New MI-8 Line Layout

(Oct 29, 2003, unit in inches, not to scale)

Changes in the New MI-8 Line

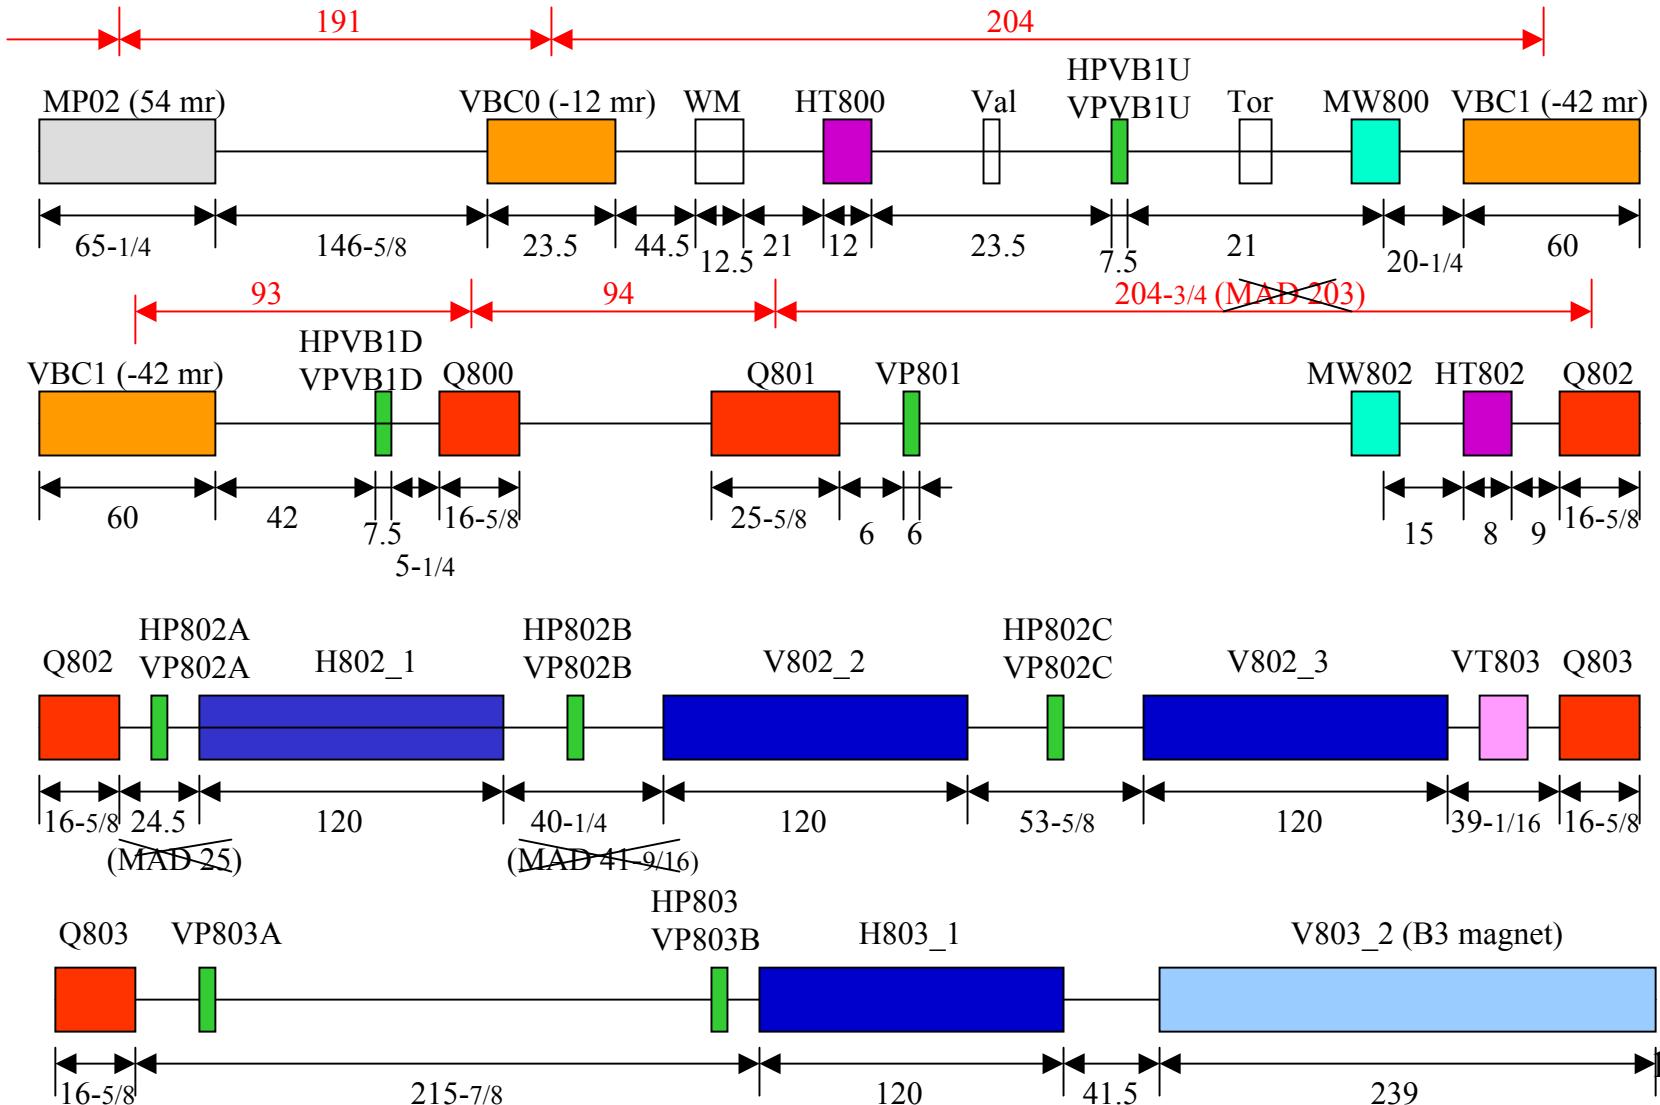
- *VBC0*: new addition (C-magnet)
- *MP02*: slight movement in location and change in bending angle
- *VBC1*: slight change in bending angle
- *H802_1, V802_2, V802_3, H803_1*: new magnets with larger aperture and sagitta, replacing the old ones
- Corrections in the MAD file:
 - Use the measured component lengths (some of them are different from that in the present MAD file)
 - Switch the position of Multiwire *MW800* and BPM *HPVB1U/VPVB1U*
 - Move the BPM *HPVB1D/VPVB1D* closer to *Q800*
 - Change the trim dipoles *HT800* and *HT802* from “kicker” to “Rbend”
- Some discrepancies between measurement and the original MAD file in magnet spacing were found. The measured values are used in the new MAD file.
